Supplement Analysis
for the
Crooked River Valley Rehabilitation Project
Environmental Impact Statement
(DOE/EIS-0506/SA-01)

Bonneville Power Administration
Department of Energy

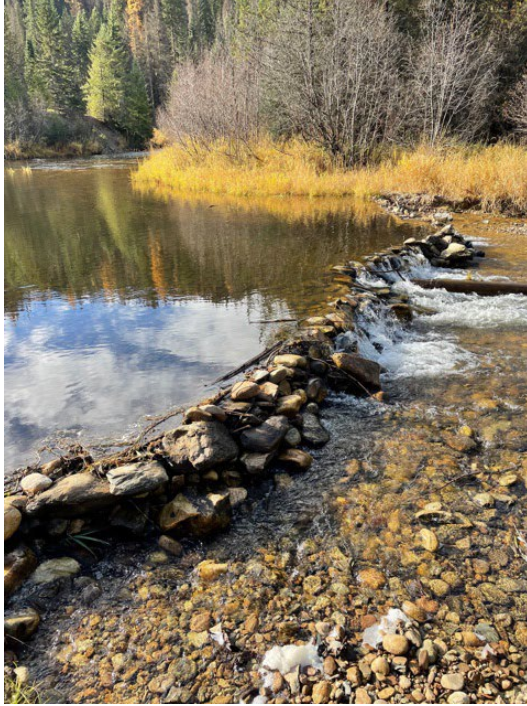
The second proposed change is to construct a rock weir that allows fish passage in lieu of installing two log structures. The rock weir would be installed near Campground 4. This rock weir structure would move the thalweg to the middle of the river channel and reduce erosion along the outer stream bank. This structure would also serve as a swimming hole for the recreationists that use Campground 4. The public annually constructs a rock dam across the channel to provide a swimming hole (Figure 1). The rock dam impedes fish passage for juvenile fish. Constructing a designed rock weir that passes all life stages of fish would provide for adult migration at all flows, create pool habitat for fish, and prevent impromptu dam construction that blocks/delays juvenile fish passage. Installing the rock weir would eliminate the need for a large wood structure along the bank near the campground where the public accesses the river.

Installation of the rock weir would include constructing the weir using large boulders, sized to withstand high spring flows. Footer boulders would be partially buried in the channel and banks, with a second layer of boulders keyed in on top of the footer boulders. The weir would create a pool upstream of the weir. A low notch in the center of the weir would concentrate the river thalweg in the middle of the river. Installation would occur in two sections, and disturb approximately 2,500 linear feet (1,250 feet on each side of the river) of streambank. The work area on one side of the river would be isolated using cofferdams (bladder coffer if bulk bags are not effective) placed using an excavator operating from the streambank. Cofferdams would be removed and the work area slowly rewatered. After rewatering, the second half of the construction site on the opposite stream bank would be isolated using a cofferdam, the remainder of the weir constructed, the cofferdam removed, and the site slowly rewatered.
